Commissioner's Decision #1467

Application No: 2,604,346

DECISION OF THE COMMISSIONER OF PATENTS

- [1] This recommendation concerns the review of rejected Canadian patent application number 2,604,346 (“the instant application”), which is entitled “HYDRO TORQUE ELECTRIC GENERATOR” and is owned by EUGENE GEORGE SEYMOUR (“the Applicant”). A review of the rejected application has been conducted by the Patent Appeal Board (“the Board”) pursuant to paragraph 30(6)(c) of the *Patent Rules*. As explained in more detail below, our recommendation is that the Commissioner of Patents refuse the application.

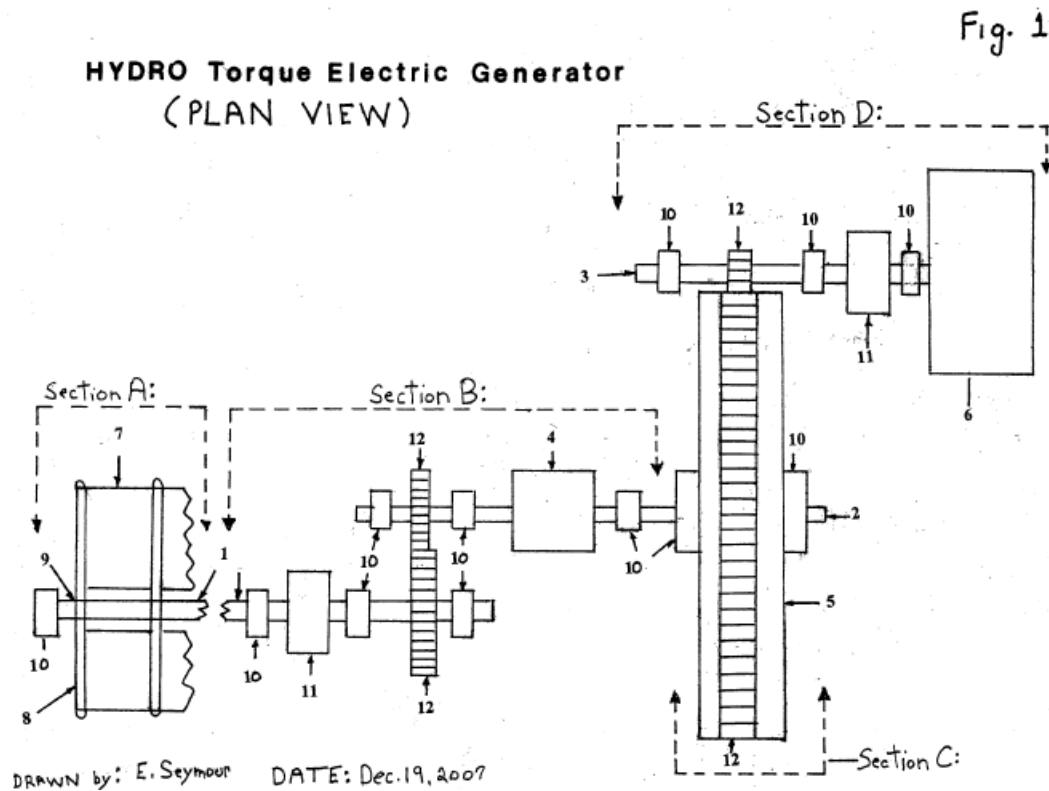
- [2] The instant application was filed in Canada on September 6, 2007 and was laid open to public inspection on March 6, 2009.
- [3] The instant application relates to an apparatus for generating electricity from a flow of water that uses a paddle wheel to turn a combination of shafts connected by gears, a clutch and a transmission. The apparatus also includes a large flywheel and an electric generator to convert the rotational energy input by the flow of water to electric energy. Figure 1 of the instant application, reproduced below, illustrates the arrangement of components that form the Hydro Torque Electric Generator. We note that though Figure 1 indicates a date of December 19, 2007, it was submitted to the Patent Office on March 9, 2009:

the introduction of the heavy weights on the side of the flywheel in the description and drawings, the introduction of the idea of simultaneous amplification of torque and velocity in the description and the introduction of a specific amount by which the paddles protrude into the water in the description constitute unacceptable new matter not reasonably to be inferred from the original specification or drawings, contrary to section 38.2 of the *Patent Act* and must be removed.

- [37] However, the content of both the drawings and the rest of the specification were substantially altered during the prosecution of the instant application. For example, the original specification dated September 6, 2007 consisted of four points of two or three lines each that discussed the basic components of the system with little or no detail and no discussion of the accompanying drawings. The original application also contained only one drawing that lacked any indication of weights to be attached to the flywheel.

- [38] In contrast, the currently pending specification consists of nine pages of text and the drawings now consist of Figures 1 to 7, showing various views of the components and details that were not present in the original drawings. With respect to the corresponding US Patent, we note that the content of the application that was originally filed in the US was significantly different than that originally filed in Canada (as contained in the Image File Wrapper that may be accessed via the US Public PAIR online file docket).

- [39] In light of the above, it is our view that the introduction of the heavy weights on the side of the flywheel in the description and drawings, the introduction of the idea of simultaneous amplification of torque and velocity in the description and the introduction of a specific amount by which the paddles protrude into the water in the description constitute unacceptable new matter not reasonably to be inferred from the original specification or drawings, contrary to section 38.2 of the *Patent Act*. While this defect could be remedied by amendment, in light of our conclusion below as to the obviousness of the claims, the requirement for such an amendment is moot.
